typ modelu:

LI48A

27246

Przewodnik Dokumentacji Technicznej

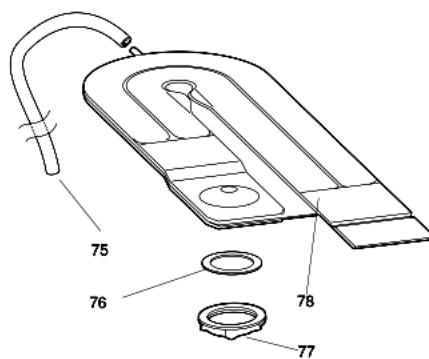
n1045034: New top condenser.

As of the last week in July 2000, the new "Wind drying system" was inserted on some appliances from the new MarckII Range. This new system foresees the elimination of the lateral air-flow body and the insertion of a new system with top condenser.

The new part numbers are not interchangeable with the old ones, as they are completely different. See technical drawing attached to notice NT002500.

Whereas the new spare part numbers are:

076238 - WIND DRYNG SYSTEM CONDENSER

076239 - CONDENSER RING NUT

076240 - TOP CONDENSER GASKET

076241 - TOP CONDENSER PIPE

77 - 076239

78 - 076238

75 - 076241

76 - 076240

Photo N1045062FIG1 illustrates the bottom of the dishwasher with EVO structure.

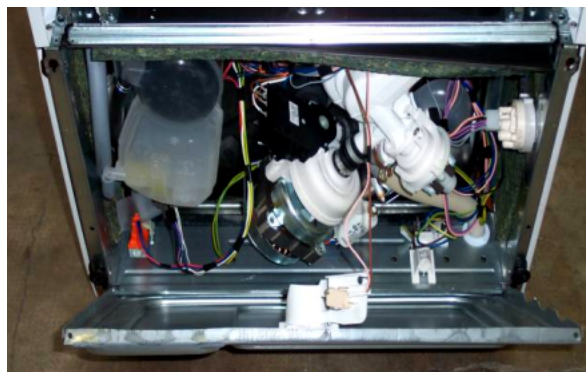
n1045062: Introduction of a new DW EVO structure

From serial number 30101.0001, all dishwasher models affected by this modification have been produced with EVO structure. These models have been equipped with NEW TRAYS AND NEW FEET (see N1045062TAB1).

EVO STRUCTURE:

Tray: 092558 (for commercial code 28490) 092554 (for commercial code 26043-23520-28088);
Tray rear feet: 092820-092821-092822;
Tray front feet: 092555;
Front feet supports: 065836;
Feet supplied with plinth accessories assembly: 034261.

Regulation assembly DX/SX Sat codes 078397 and 078396 will be managed up to stock end, after that they will be replaced by new Sat codes 092821 and 092820. The same is for rear foot Sat code 078385 which will be replaced by Sat code 092822.

N1045063

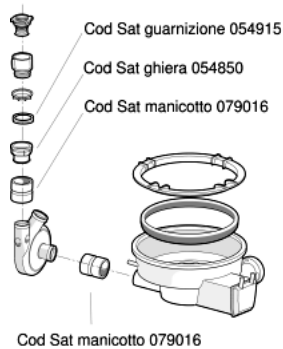
n1045063: Introduction of coupling+ring nut Sat code 093752

From serial number 30224.0001, all dishwashers affected by this modification have been equipped with the new coupling+ring nut assembly Sat code 093752, in place of coupling Sat code 079016, ring nut Sat code 054850 and gasket Sat code 054915.

Picture N1045063 illustrates the premodification structure in FIG1 and the new structure in FIG2.

Ring nut Sat code 054850 will continue to be available from the spare parts warehouse while stocks last, and coupling Sat code 079016 will continue to be stocked because it is still used for the tank-volute connection.

N1045081FIG1

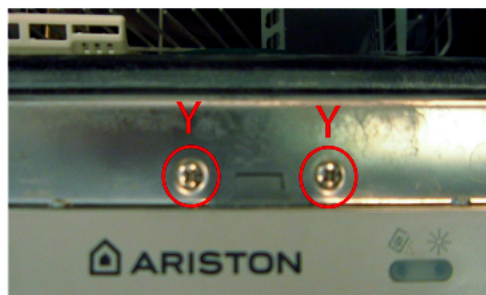
n1045081: Modification of locking units and inside doors on 45 cm dishwashers.

From serial no. 40419.0001, all 45 cm dishwashers affected by this note have been equipped with the locking unit code 094128 in

place of 085357 and 087440.

Following the elimination of the two screws Y (see N1045081FIG1) used to fix the locking unit on the inside door, the locking unit and inside door were also modified, which can be mounted on premodification appliances by replacing the premodification locking unit with the new one.

Codes of modified inside doors:

091542 (EX 088175) PREMODIFICATION - 110184 NEW

091540 (EX 087151) PREMODIFICATION - 110185 NEW
